Job Name:
 Batavia High School

Submittal:
Batavia High School

Description
Packaged Water Chillers

**DAIKIN AIR-COOLED SCROLL CHILLER
SUBMITTAL DATA**

Unit Dimensions

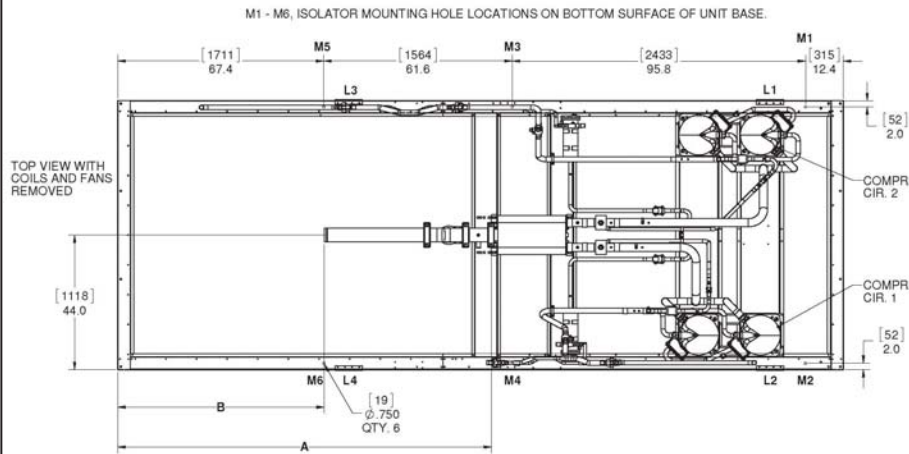
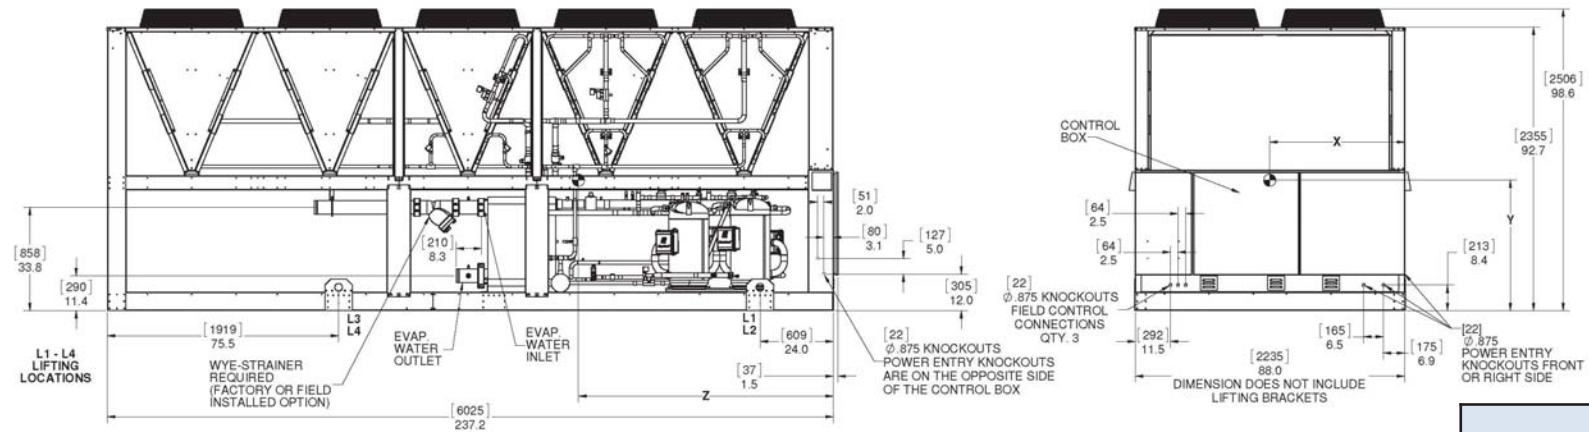
Contractor to review concrete pad dimensions and coordinate with GC on pad revisions required. Units are longer than existing units on site.
